Golder Associates Inc.

September 29, 2003

RE: FLORIDA POWER & LIGHT COMPANY (FPL) – MANATEE UNIT 3 STACK AND LOCATION
 REFINEMENTS, PSD-FL-328, FDEP FILE NO. 0810010-006-AC,
 SITE CERTIFICATION PA 02-44
 UPDATES IN NEAR-FIELD AIR QUALITY IMPACTS

Table A-2. FPL Manatee Summary of Unit-3 Project Layout Enhancements

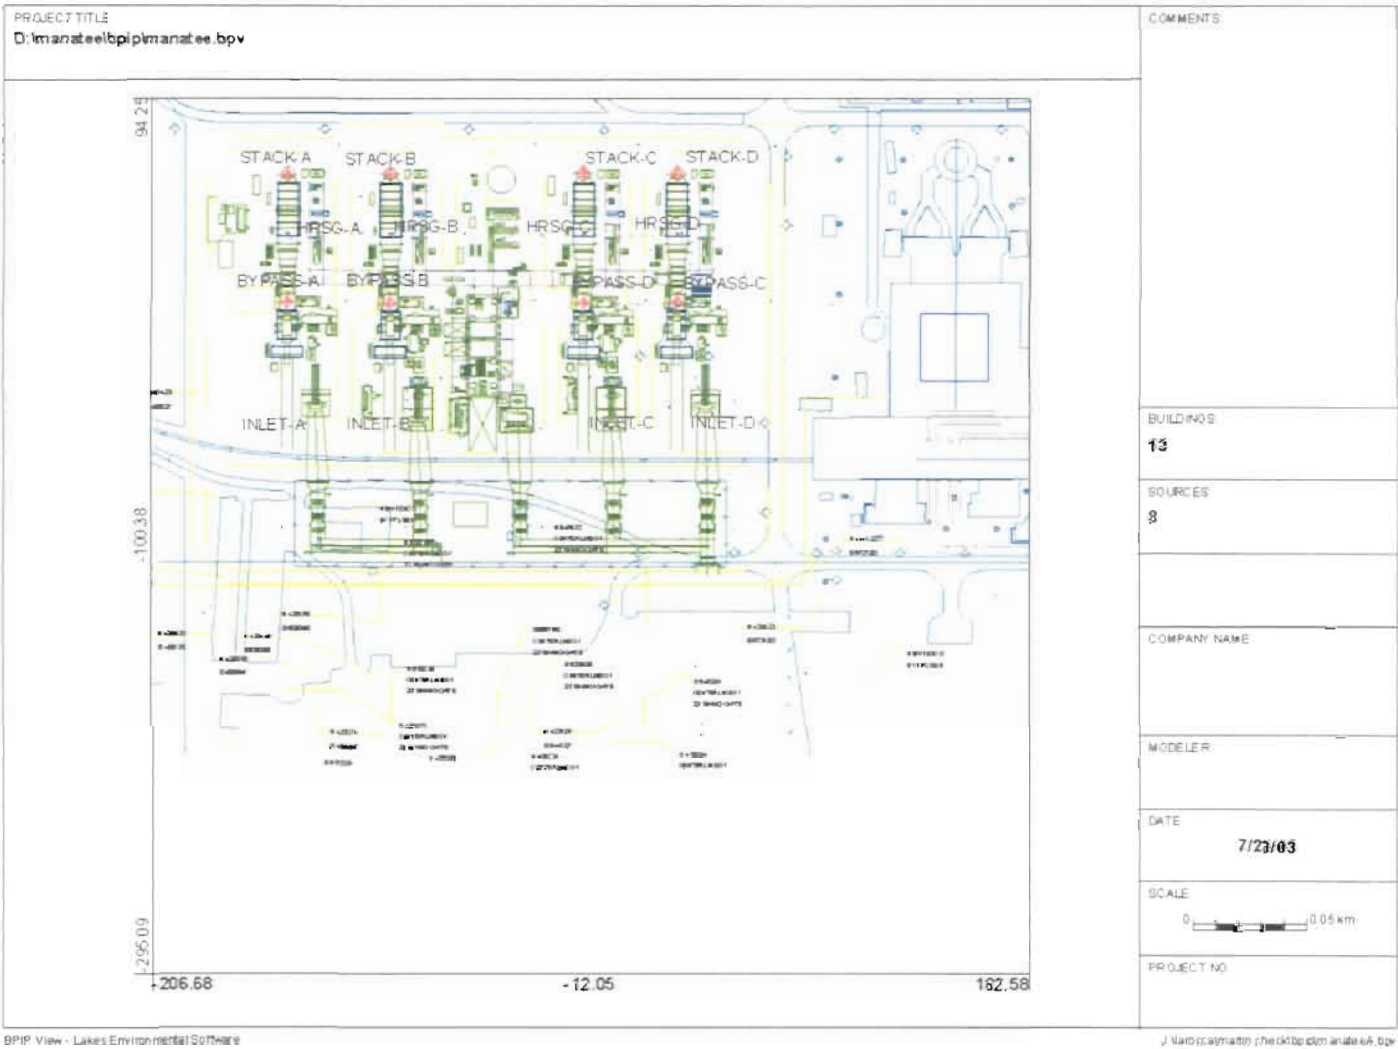
New Layout	Old Layout	Comment	NEW Local Cord (x)	NEW Local Cord. (y)	OLD Local Cord. (x)	OLD Local Cord. (y)
	(m)	(m)		(m)	(m)	(m)	(m)
HRSG A Stack Height	44.2	36.6	New Location	-147	60	-152	55
HRSG B Stack Height	44.2	36.6	New Location	-101.3	60	-107	55
HRSG C Stack Height	44.2	36.6	New Location	-15.3	60	0	55
HRSG D Stack Height	44.2	36.6	New Location	26	60	45.7	55
Bypass A Stack Height	24.38	24.38	New Location	-147	3	-152.7	0
Bypass B Stack Height	24.38	24.38	New Location	-101.3	3	-107	0
Bypass C Stack Height	24.38	24.38	New Location	-15.3	3	0	0
Bypass D Stack Height	24.38	24.38	New Location	26	3	45.7	0
HRSG Height	25.3	25.3					
HRSG Width	9.5	9.5					
HRSG Length	22.7	22.7					
Air Inlet Height	13.72	13.72	Air inlets in new layout are located closer to the bypass stacks, see BPIP figure.				
Air Inlet Width	7.3	7.3					
Air Inlet Length	14.72	14.72
